**Arborist Review**  
**Montrose Wintergarden Hotel,**  
**1106 Blanshard Street Victoria, BC**

Date submitted: Amended for November 16, 2020

project no.	120.09
scale	1: ### @ 24"x36"
drawn by	MDI
checked by	SMF:DG
revision no.	sheet no.
	<b>L0.01</b>

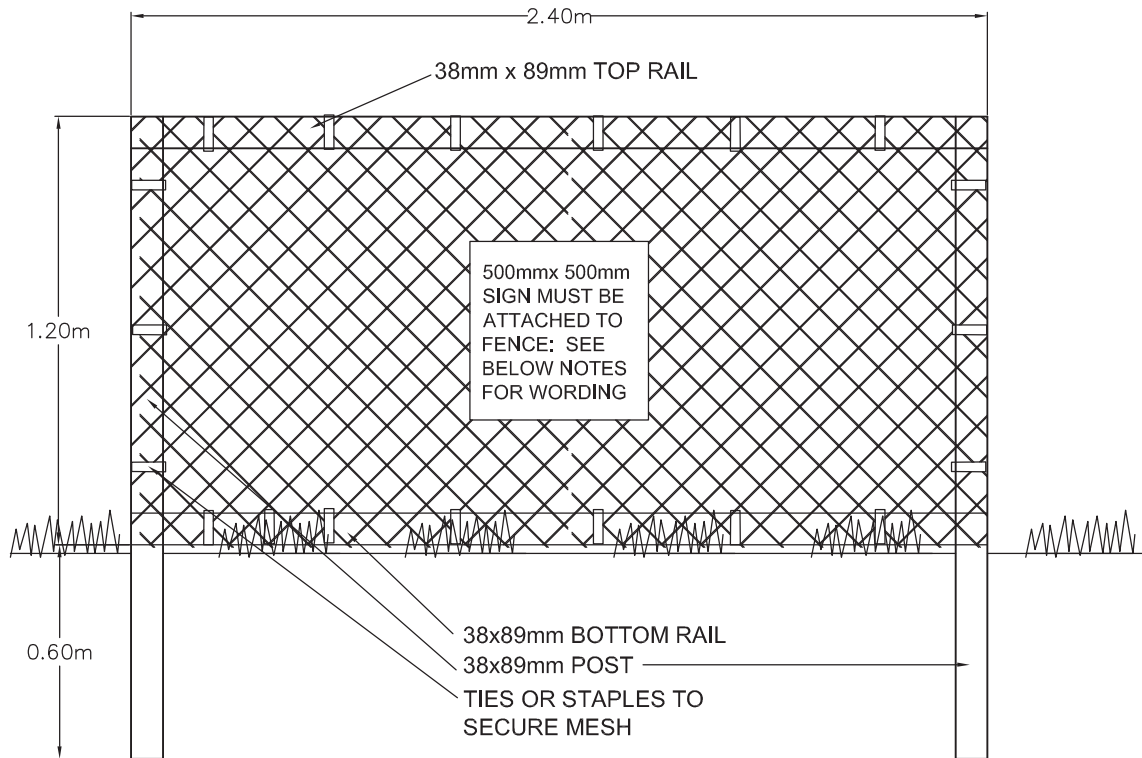
**Servicing:** The civil drawings that were reviewed indicate that all the proposed underground services are located outside the critical root zone areas of trees that are to be retained. The storm service and domestic water/fire connections are located near the root zone of Beech 9648 and a Street lighting chamber and connection are located close to the root zone of Beech #9646. Arborist supervision is recommended for the excavation through the municipal frontage adjacent to these trees.

The street curbing is proposed to be removed and relocated an additional 1.5 metres further into the street and away from the trunks which will reduce the impacts on the trees when the curbing is replaced.

- All the trees that are to be retained must be isolated from the construction impacts by erecting protective barrier fencing or solid hording.
- All excavation within or along the edge of the critical root zones of trees that are to be retained, must be supervised by an ISA Certified arborist.
